Variance Request Site Plan

2721 Creek View Drive

V-106
(2015)

APPLICANT: Jeffrey and Bettina Oeschger **PETITION No.:** V-106

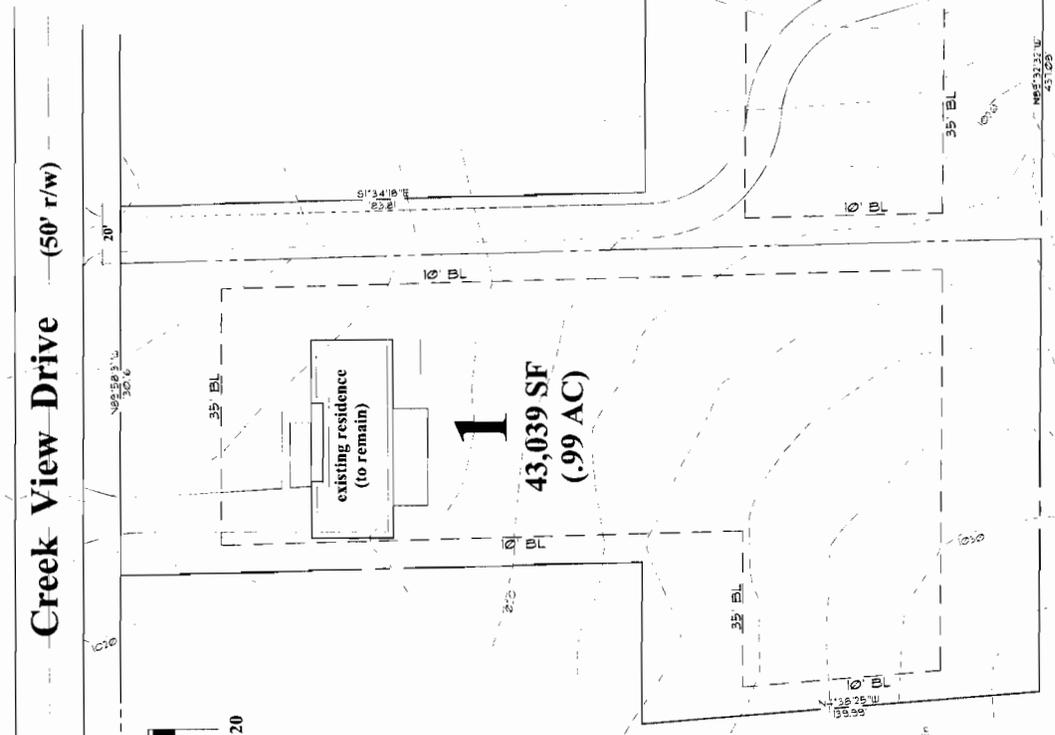
STORMWATER MANAGEMENT: No significant stormwater management impacts are anticipated. Subject to site plan to be approved by Stormwater Management Division prior to issuance of building permit.

SEWER: Proposed lot 2 must connect to sewer in Creekview Drive if main floor can be served by gravity. Sewer petition extension fee will apply in addition to standard fees.
